Illinois Tollway Base Sheet Revisions

Section M	Base Sheet Drawings	
	Drawing	Modification Summary Effective: 03-01-2024
	Pole Assembly (ITS)-Series 1000	
	M-ITS-1000	Elevation Views Pole Mounted ITS Element Assembly

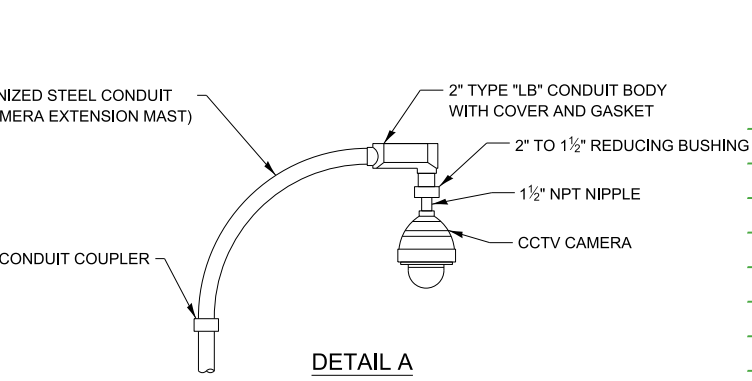
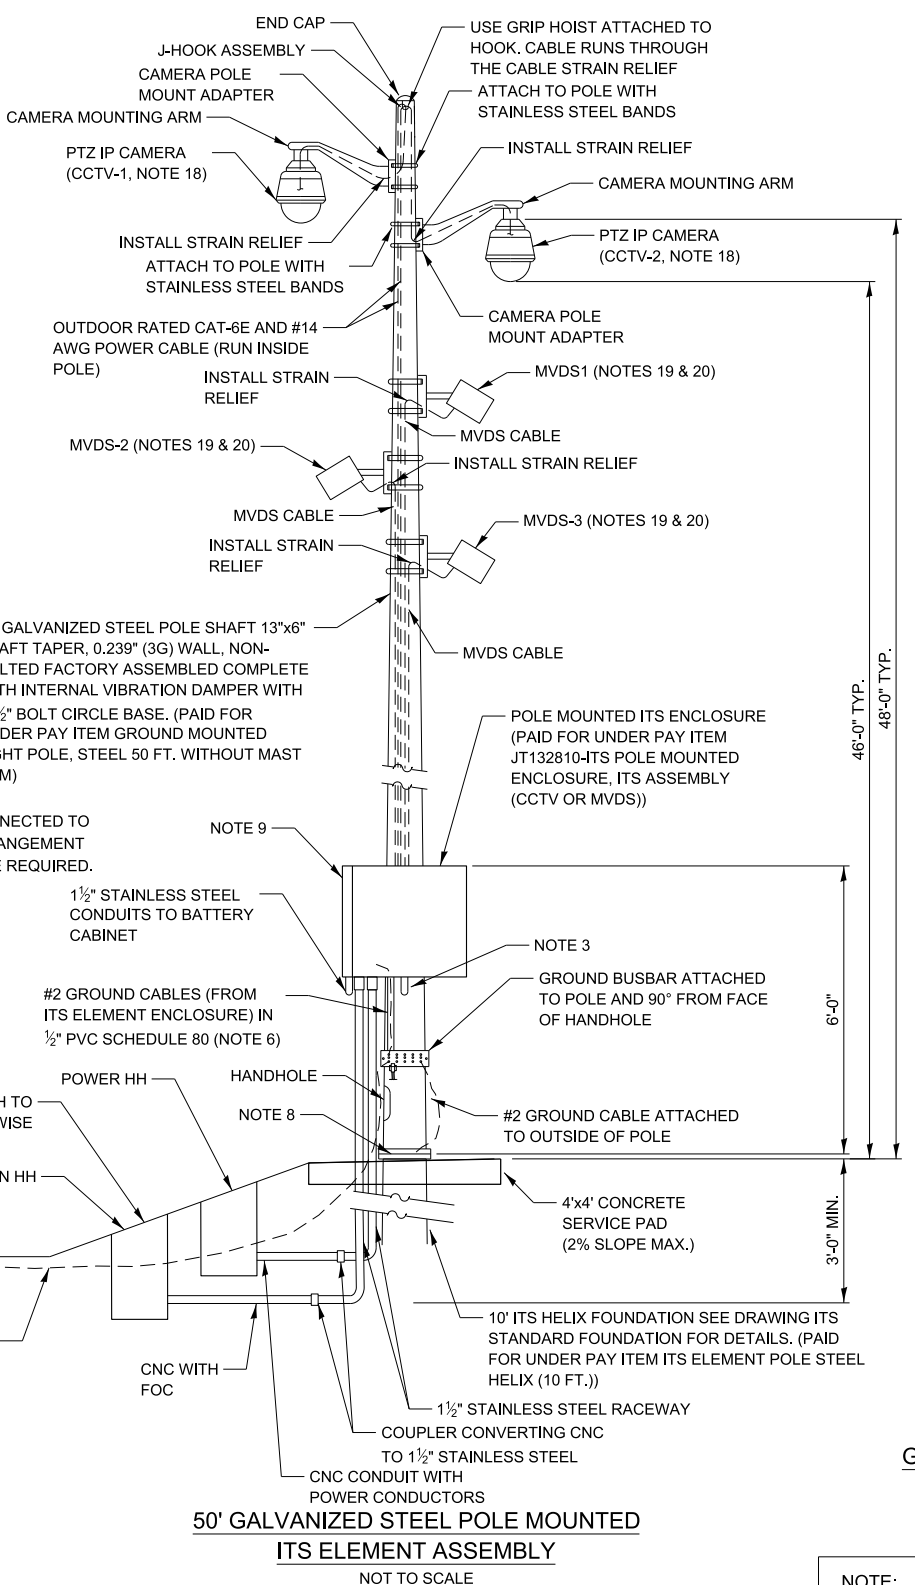
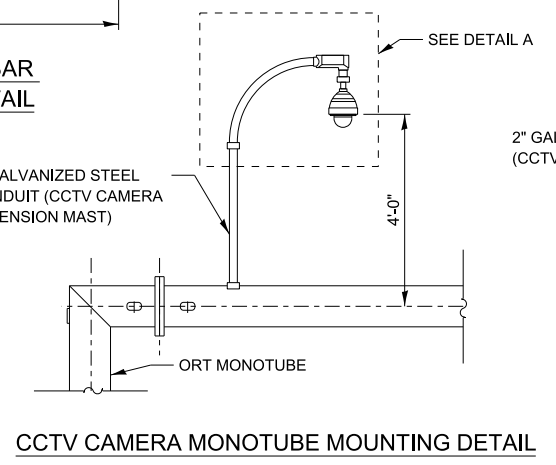
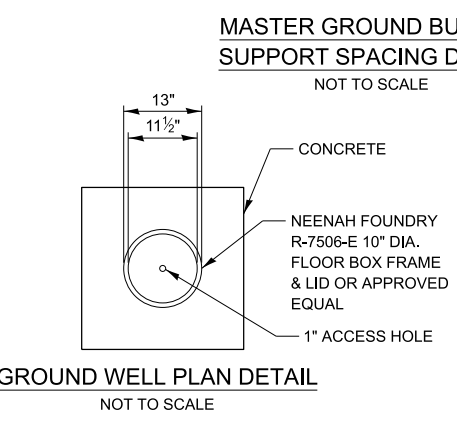
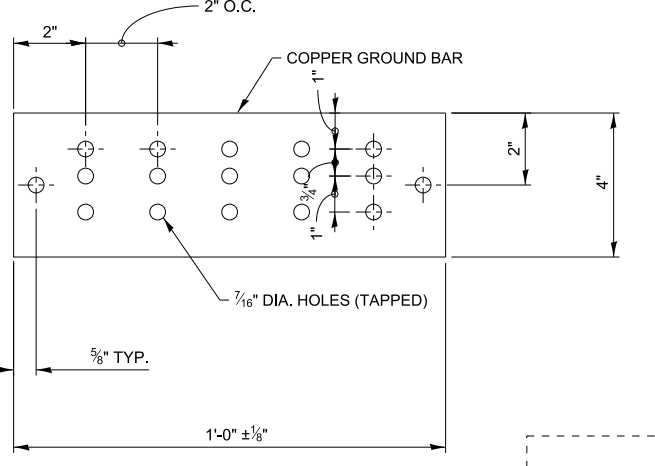
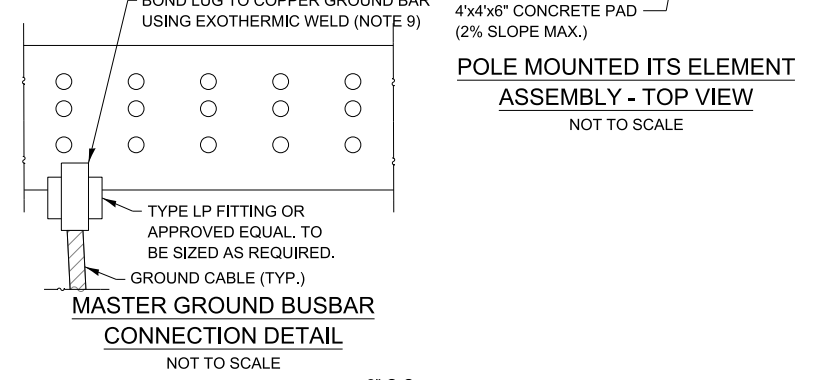
Sheet 1	Added details for grounding busbar with dimensions
		In pole assembly top view: added identification of 1-1/2" CNC conduit
		In enclosure side view" changed to one 1 1/2" stainless steel power conduit
		In pole mounted assembly details: change CCTV-2 to CCTV-1
		Replace word "round" by word "ground"
		Removed notation to 8 strand
		Added detail for locate/tracer wire connected to ground busbar
		Removed reference to Note 1 in CCTV camera monotube mounting detail

DETAIL B - TYPICAL MOUNTING ATTACHMENT CONNECTION

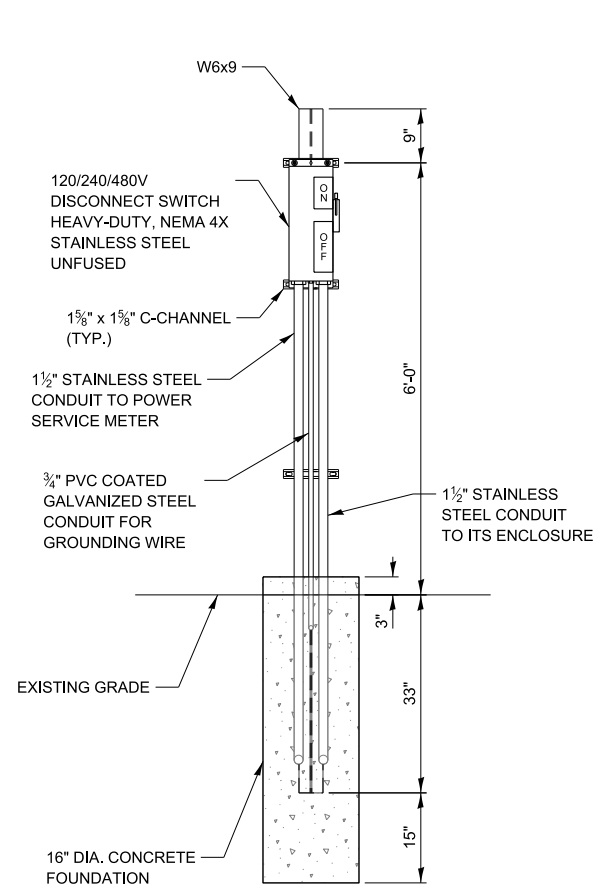
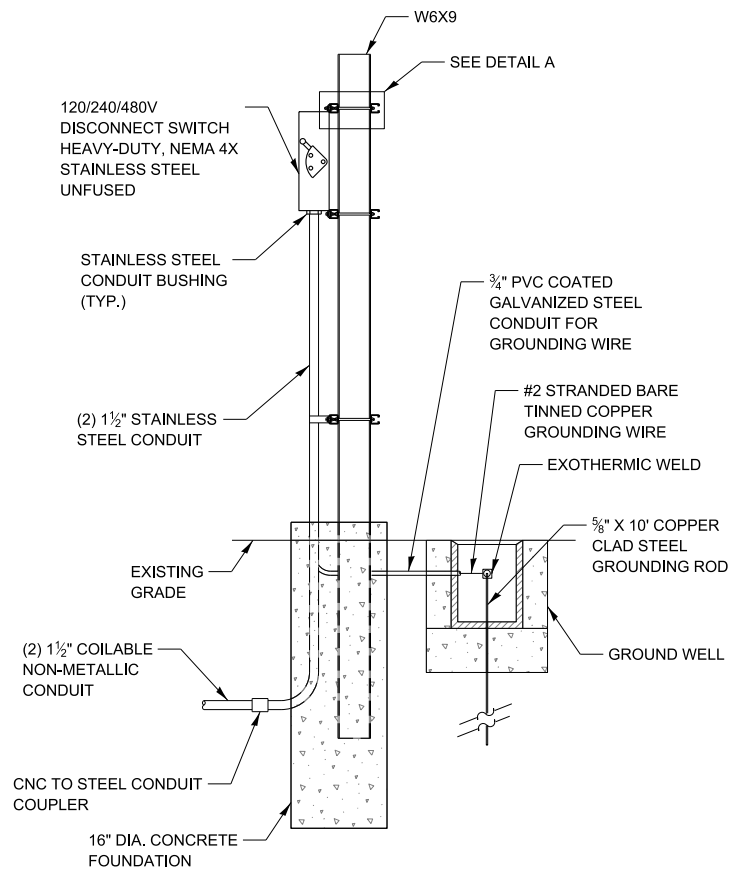
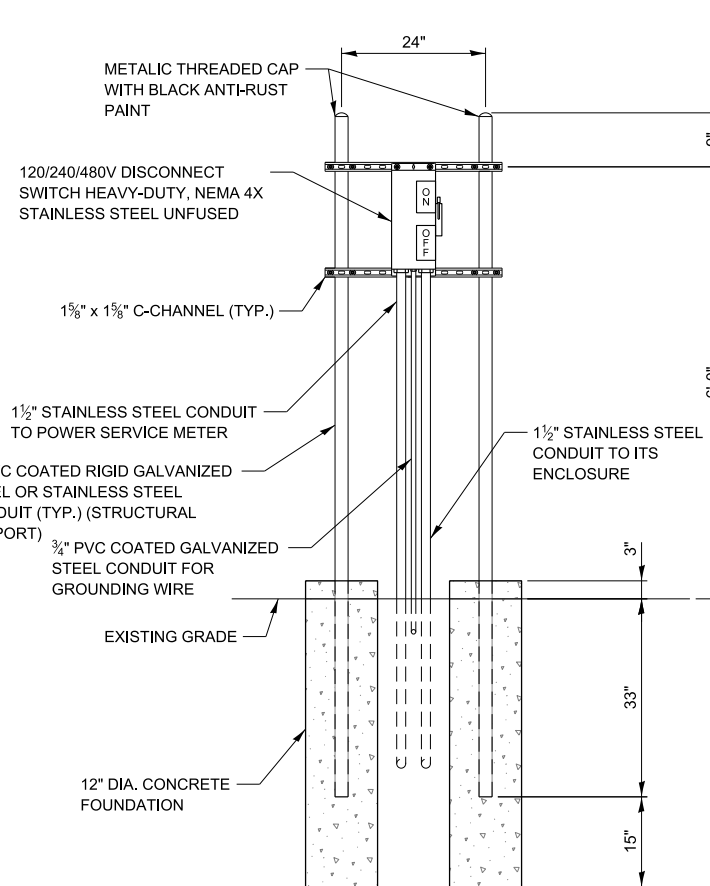
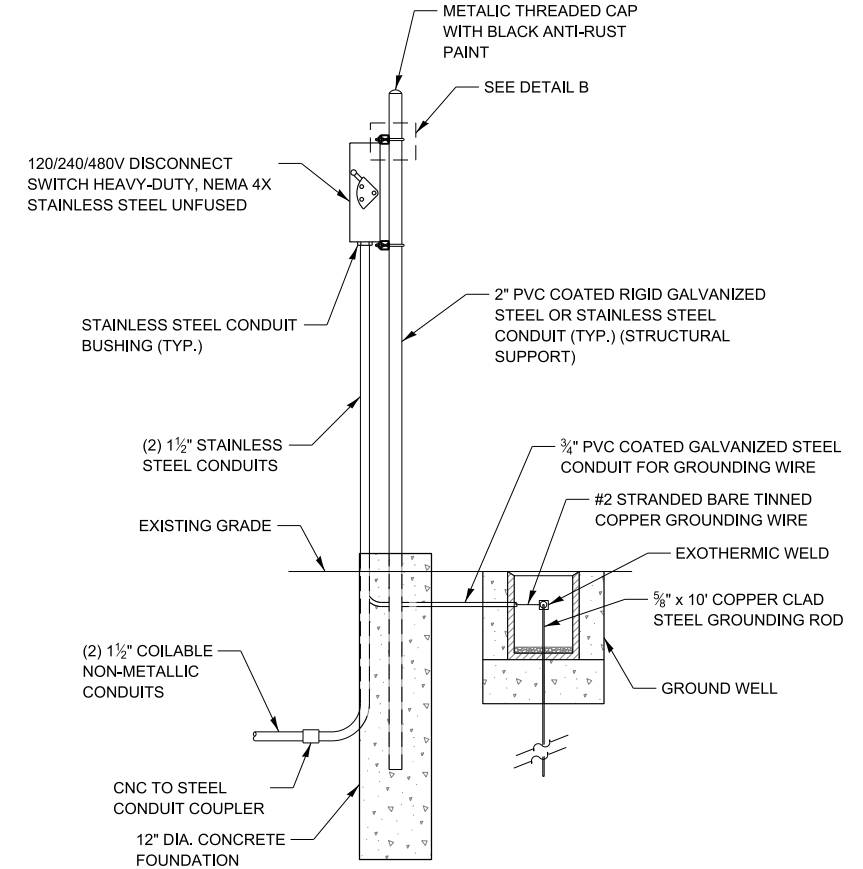
Sheet 2	Changed designation of Detail A by Detail B
		In side view of ITS Disconnect switch cast in place: changed reference to Detail A by reference to Detail B
	M-ITS-1001	General Notes Pole Mounted ITS Element Assembly
		Added Note 24: The door for ITS enclosure shall be installed vertically and on the left side of the cabinet when facing the cabinet
		Added Note to Designer: if a CCTV needs to be replaced and the distance to the Cisco switch in the Plaza communication room is greater than 300 feet but less than 500 feet, use Extended Range Ethernet Cat 6 cable. If the distance is greater than 500 feet then install a Video Power Junction Box Model B NEMA 4 near the trust structure or monotube and connect fiber link to the communication switch in communication room.
	M-ITS-1002	ITS Standard Foundation
		Changed the name for Helix Foundation Mounting Plate
	M-ITS-1003	ITS Concrete Service Pad

CONCRETE SERVICE PAD FOR ITS POLE

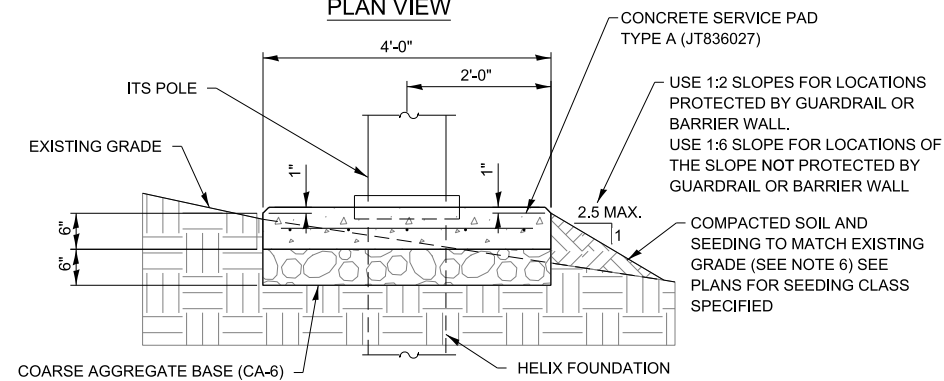
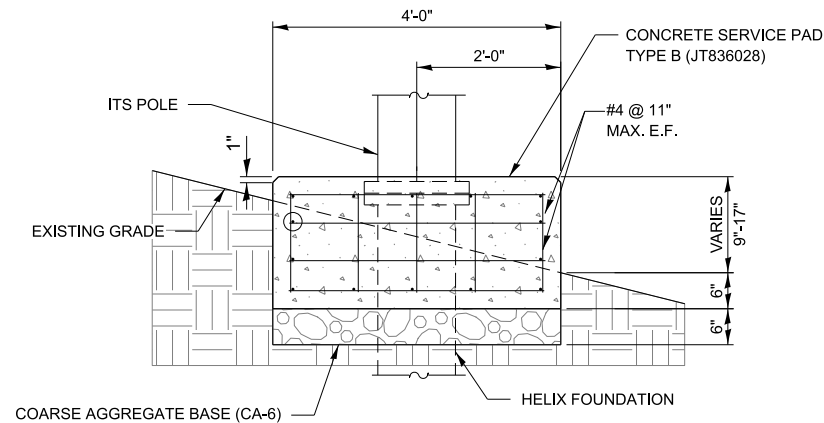
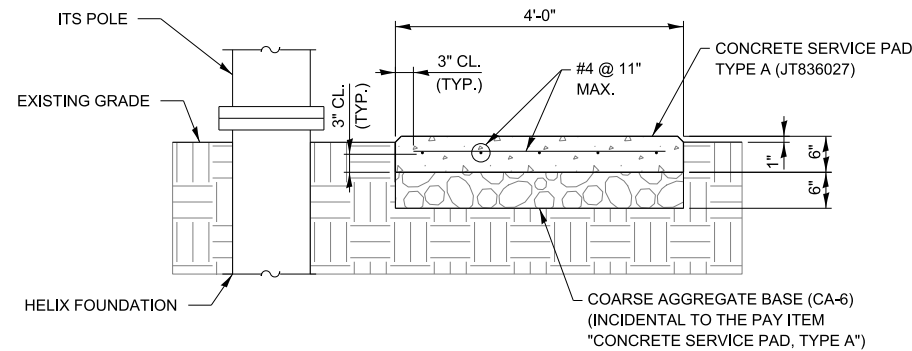
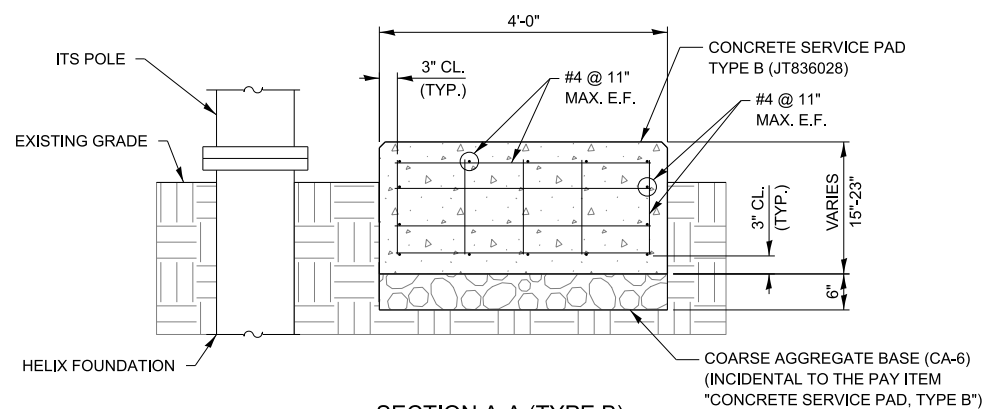
Sheet 1	Changed the orientation of the traffic arrow rotated 180 degrees
		In plan view for concrete service pad: show Section B-B arrows upward
		Delete dimension 1'-8" concrete service pad detail plan view
		Delete dimension 1.2192 in Section B-B (Type A)

**CONCRETE SERVICE PAD, TYPE C
ELEVATION VIEW**

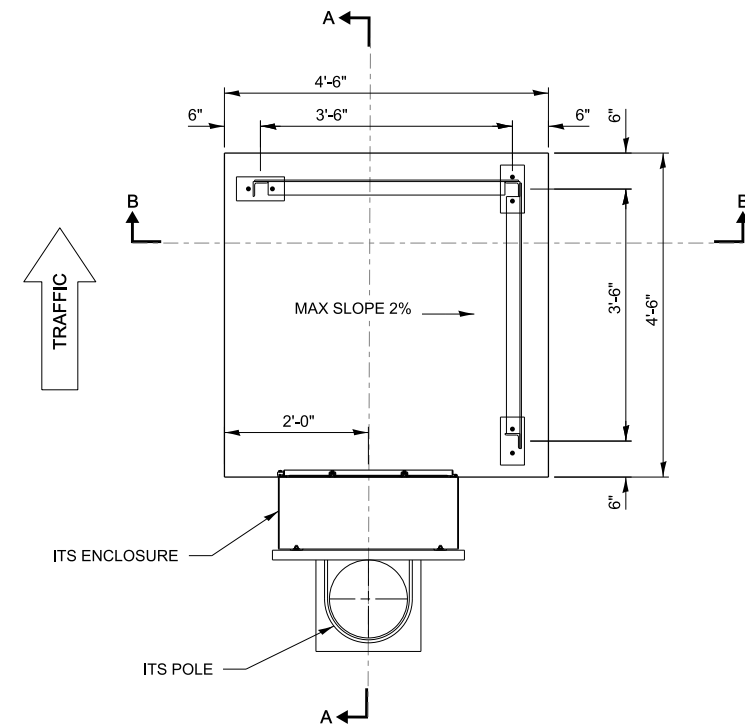
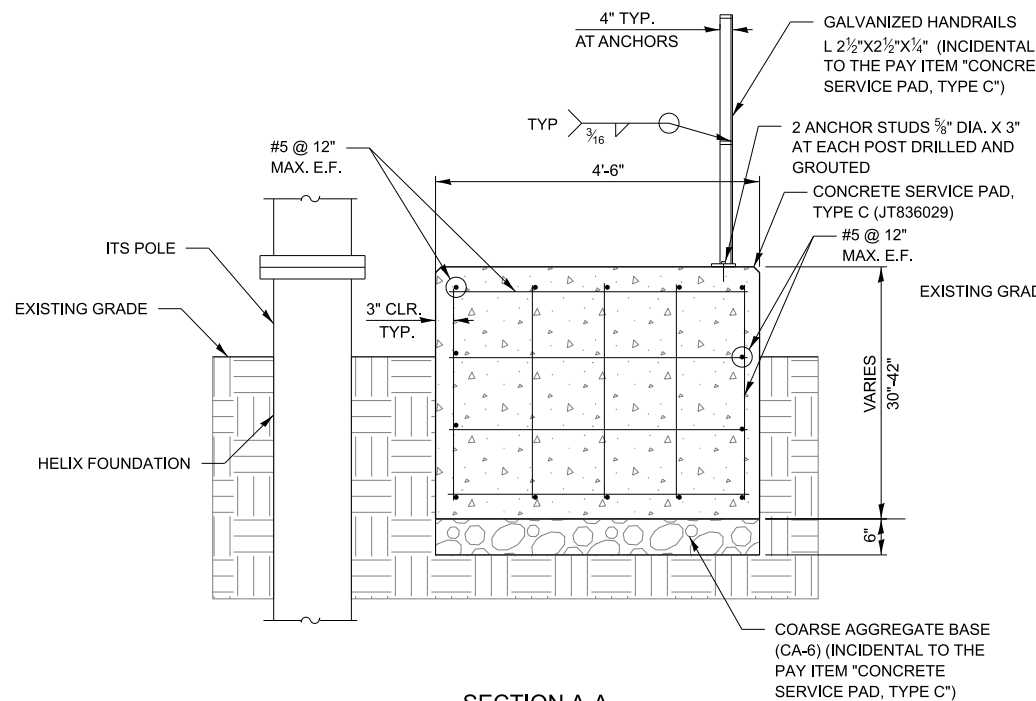
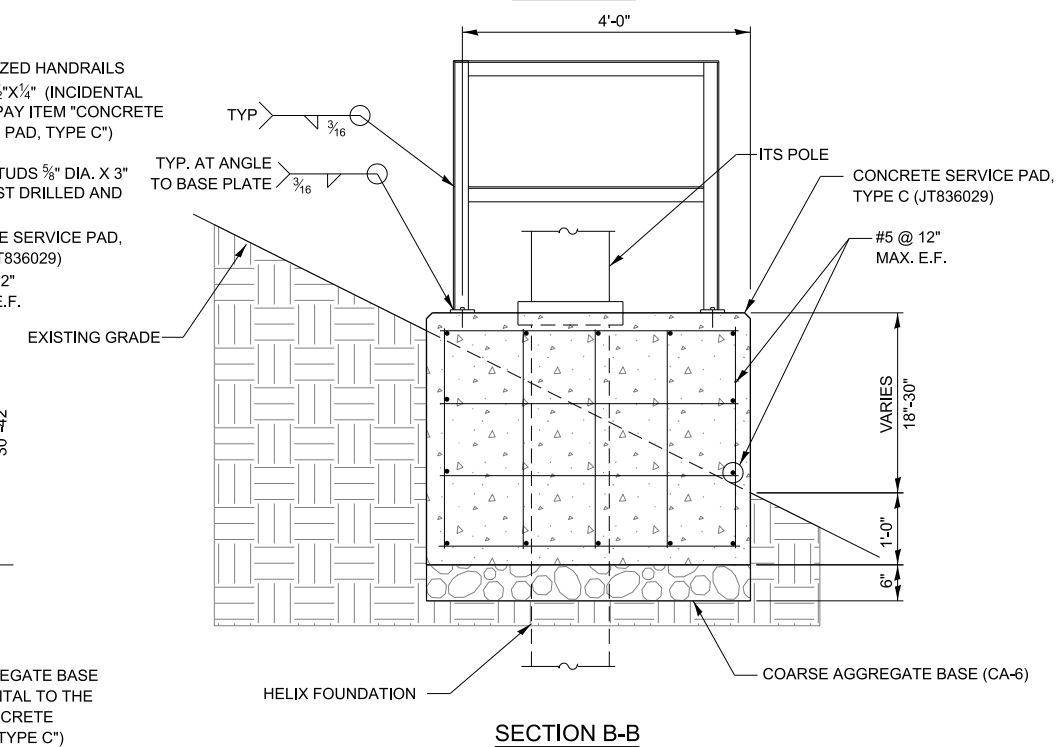
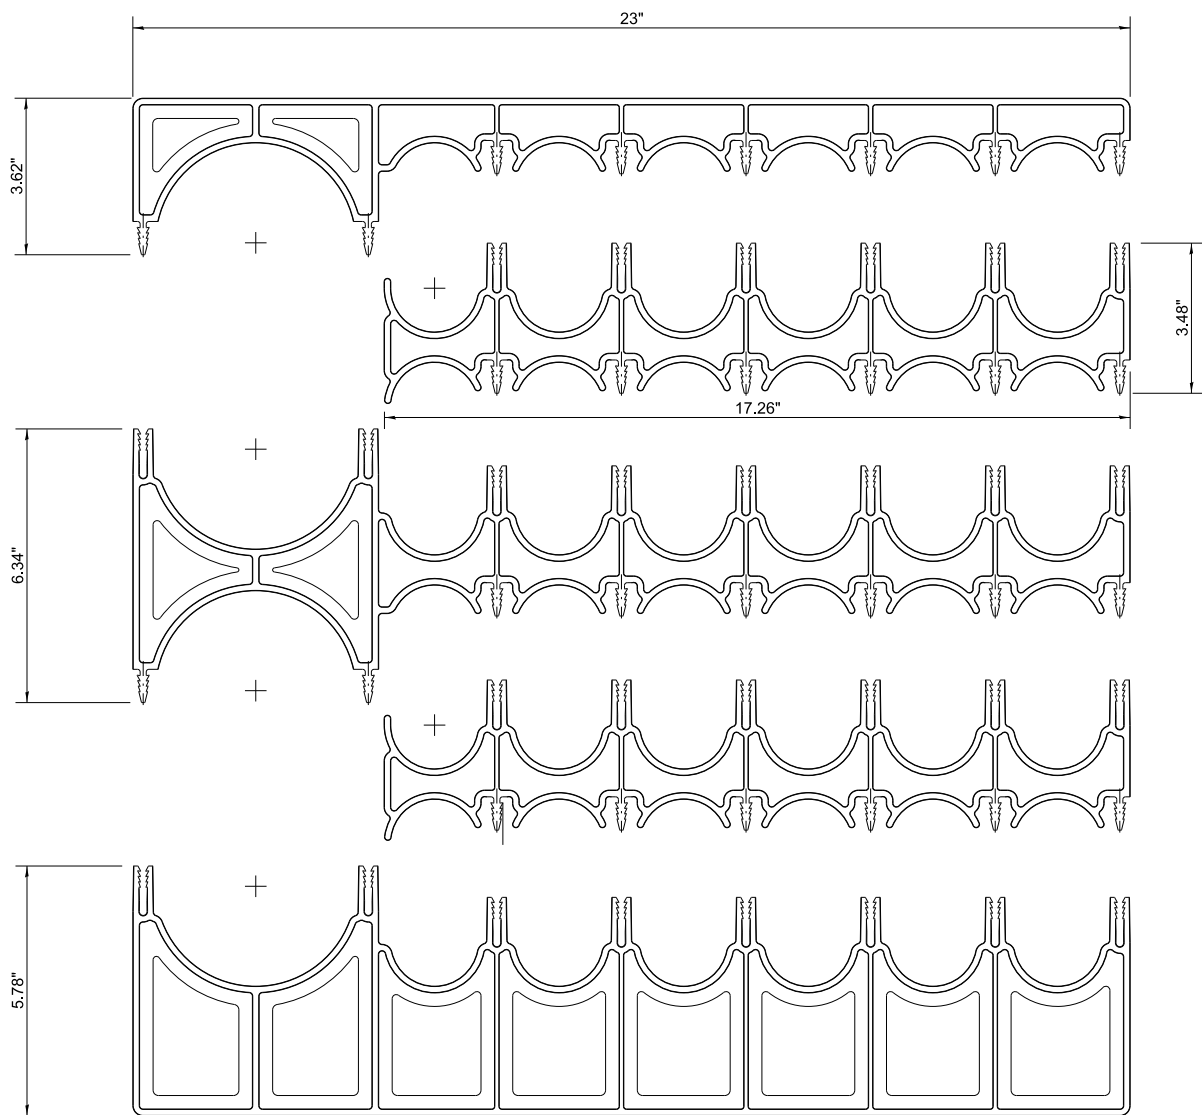
Sheet 2	Section B-B (Type A) and Section B-B (Type B): service pad 1" above grade
		Align Section B-B with Plan view on top
		In plan view for concrete service pad type C: moved arrow for Section B-B upward
		Concrete service pad Type C: service pad 1" above grade
	M-ITS-1004	Spacer - Duct Package in a Trench
		New details of duct spacer for duct bank in a trench showing the conduit arrangement for fiber and power
